TECHNICAL JUSTIFICATION

We, LG Electronics Inc., as a manufacturer of following product, hereby declare the product has hardware changes.

Basic	New
FCC ID	BEJ-TM04ANNABM0	BEJTM04ANNABM2
Grant Date	14 July 2020	-
ISED	2703H-TM04ANNABM0	2703H-TM04ANNABM2
Approval Date	30 July 2020	-

Band Differences

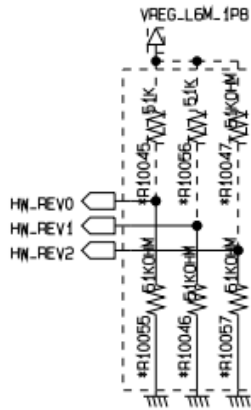
LTE 20, 26 are disabled on TM04ANNABM2. All other bands are identical with original model.

3. SHIELD CAN DIFFERENCE

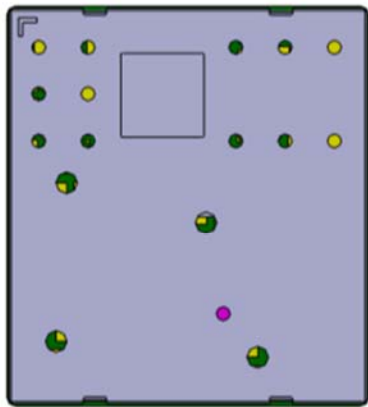
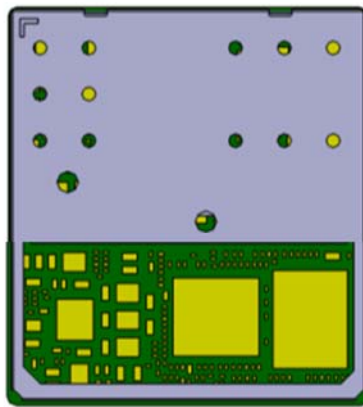
Shape of shield can has difference as below.
